EMISSION RECALL

NOx Sensor

Reference: 37D

2025-2026 (DD) RAM 3500 Cab Chassis

Figure 1 – Authorized Modifications Label

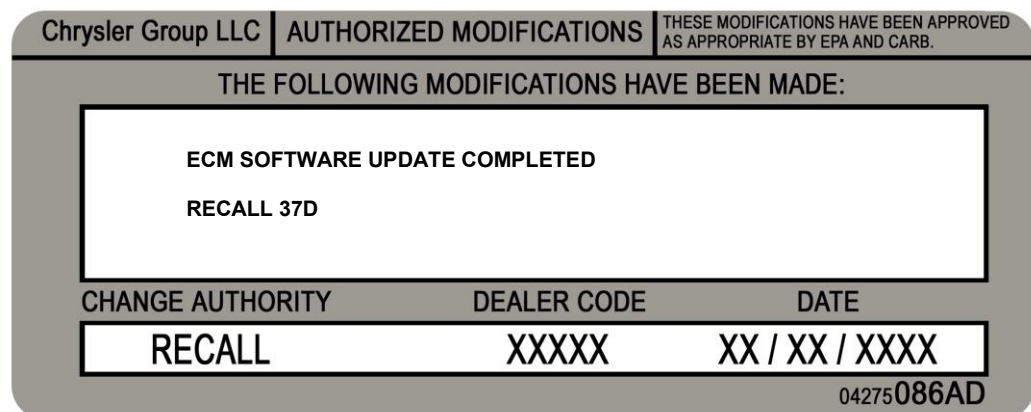
Type or print (with a ballpoint pen) the necessary information shown in Figure 1 onto the Authorized Modifications Label. Then attach the label near the VECI label.
